08/04/2016 Staff feedback on RAI 208-8245; Q 03.08.03-1

In RAI 8245, Question 03.08.03-1 (parts (a) and (b)), the staff requested the applicant to describe a) how the pressure transient for a single sparger activation was developed; and b) what cases of activation (of the spargers) may occur. The staff reviewed the structural aspect of the response to part (a) and found it to be acceptable. However, NRC also needs to review the other aspect of the response that describes the methodology for computing the PORSV spargers pressure transient for acceptance.

Figure 1. The Scaling Factor with Different Initial Pool Temperature

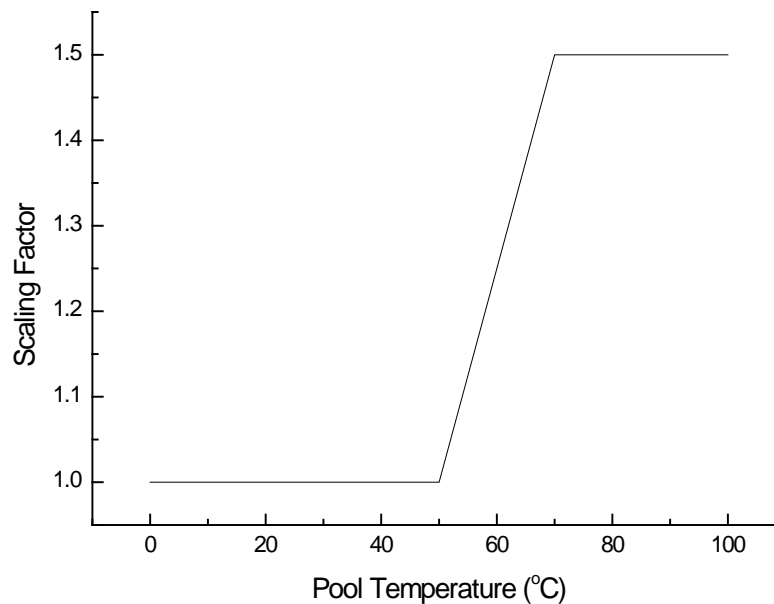
- 1) background for the scaling factors for part (a) (see below), specifically, n-sub-g, n-sub-z, and n-sub-v.
- 2) We also need to confirm that the equation on page 5/9 refers to $r > 2r_0$ rather than just "0" (We have the background info that corroborates this, so this should just be a simple confirmation of a typo).

The Studsvik tests have indicated that the maximum pressure amplitudes are increasing noticeably with increasing pool water temperature above a level of about 50-60 °C. The scaling factor to account for differences in initial pool water temperatures is shown in the Figure 1. The maximum initial IRWST temperature is 120 °F (48.9 °C). Therefore, the scaling factor to account for differences in the pool water temperature, η_T is 1.0.
